REPORT TO THE LAND USE AND FACILITIES PLANNING COMMITTEE

PROJECT:
UF-638, Student Health Care Center Phase II

DESIGN DEVELOPMENT REVIEW
DECEMBER 1, 2020

PROJECT:
UF-373, FLMNH - Special Collections Building

Parking Impacts, Cont.

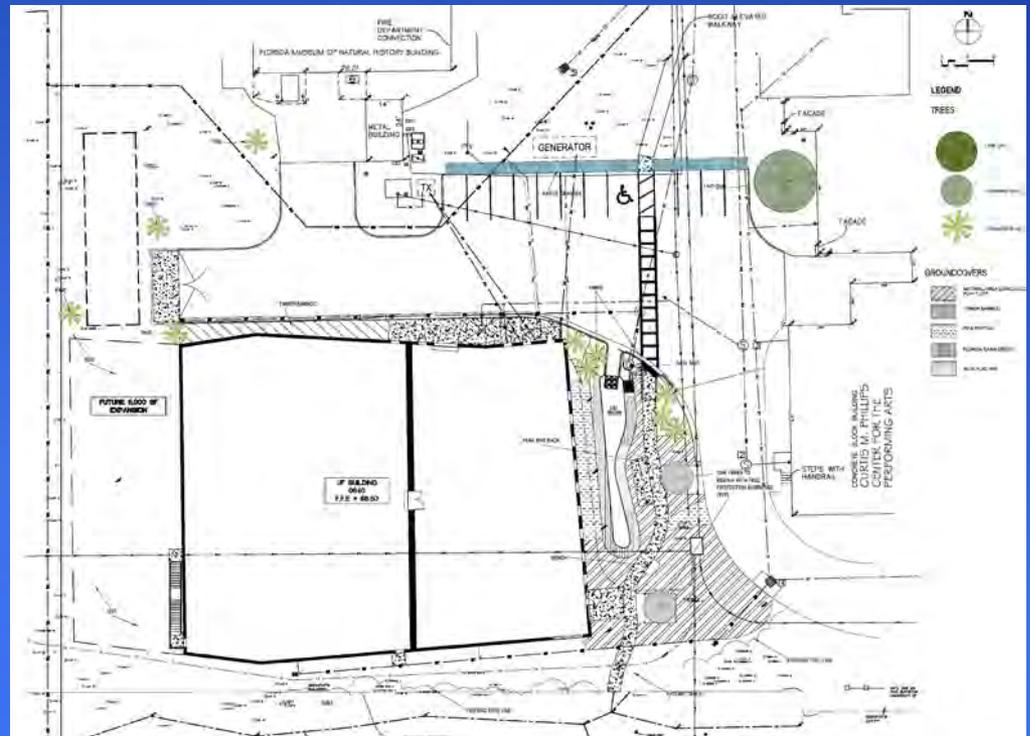
- Address Past Comments
 - Pedestrian Access to NATL
 - Revised Crosswalk configuration
 - Revised Landscaping and approach

FLMNH - Special Collections Building

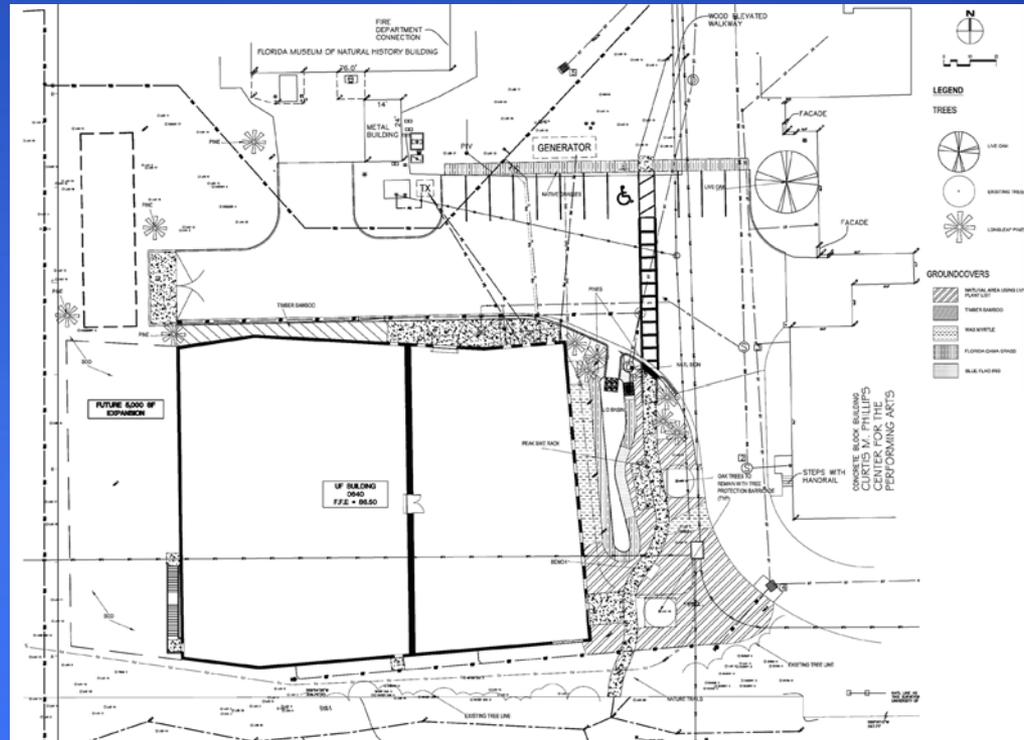
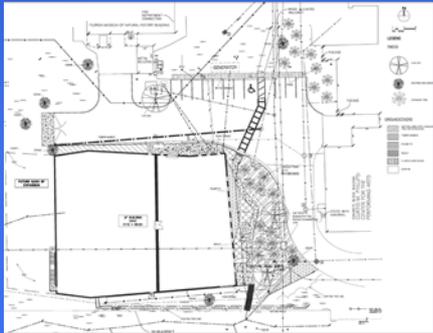
- Controlled Burns: DD Presentation to explain knowledge of issue and how building is addressing.
- Qty of tree demo: The number of trees being removed in the footprint of the 'future' addition. Do all of those need to come down now? Or is it a factor of cranes and tilt-up space too? If we can save some, that's good for Mitigation budget and LVL Committee. If not, explain why.
- No more Palm Trees and DO remove undesirable trees/shrubs.

- Address Past Comments
- Accent the access to the NATL Trail
- Modify crosswalk location

Landscaping Impacts, Cont.

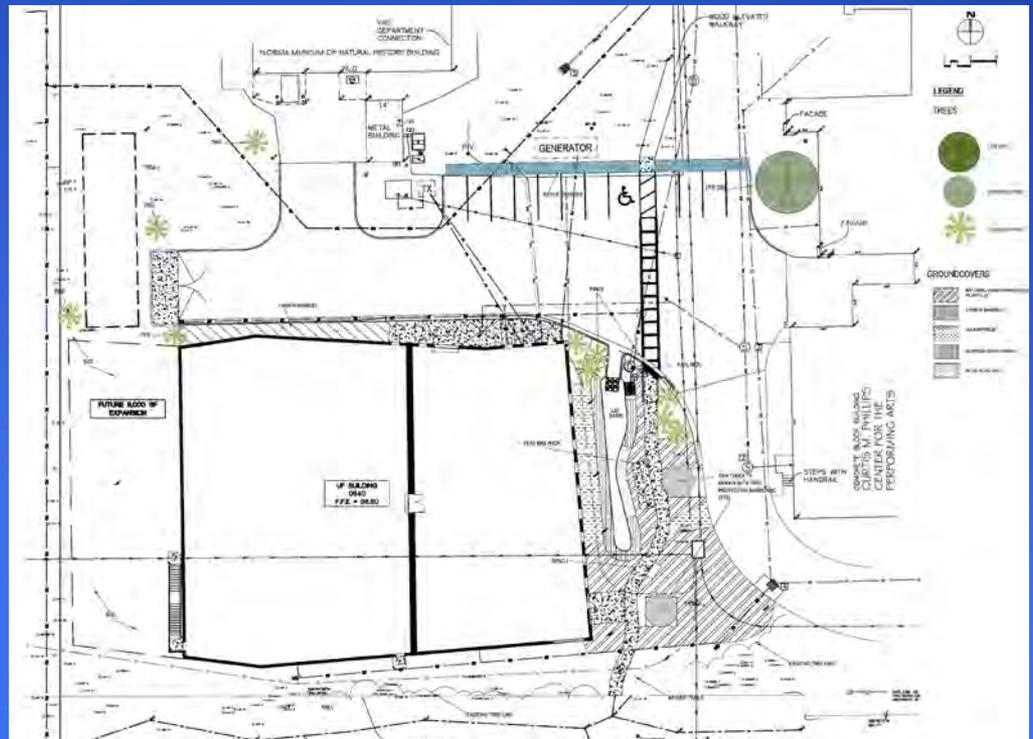
- Address Past Comments
- Remove 'weedy' trees along the fence line by the new building.
- New Landscaping around building should be native, have color, and compliment the area including, but not limited to *Sassafras albidum*, *Prunus umbellata*, *Aesculus glabra*, *Crataegus*, *Myrica cerifera*, *Baccharis halimifolia*, *Quercus incana*, *Q. laevis*.. Avoid Cedar trees due to flammability.

Landscaping Impacts, Cont.

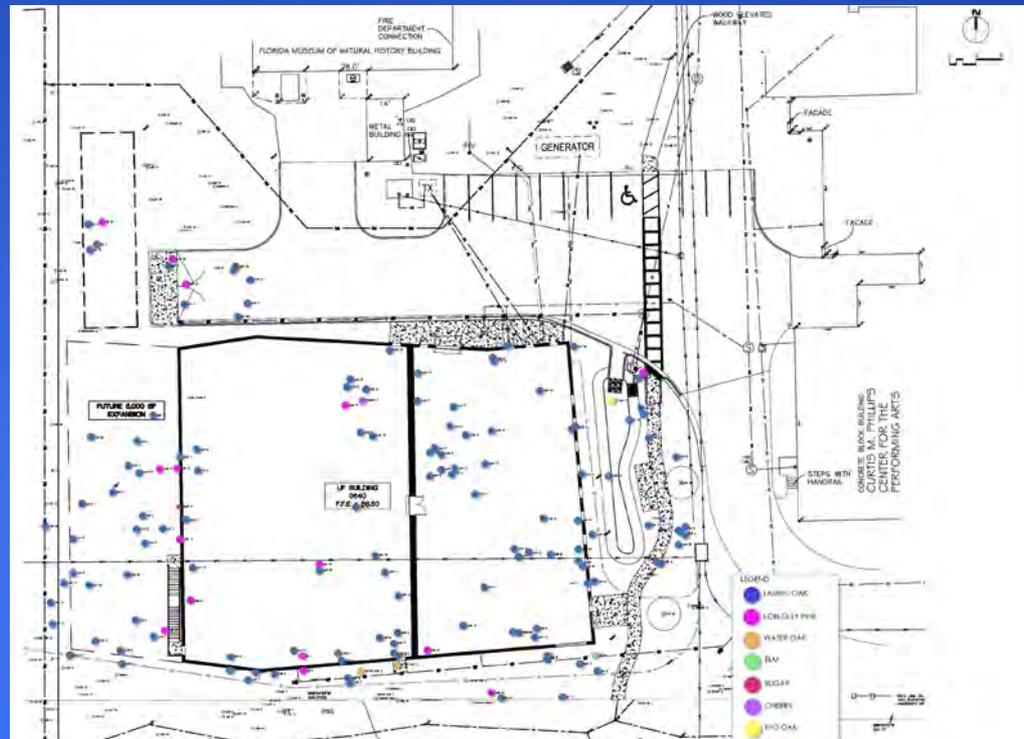
- Address Past Comments
- Move or remove building sign and add sign for NATL
- Consider an abstract design on the Entrance Wall of the building
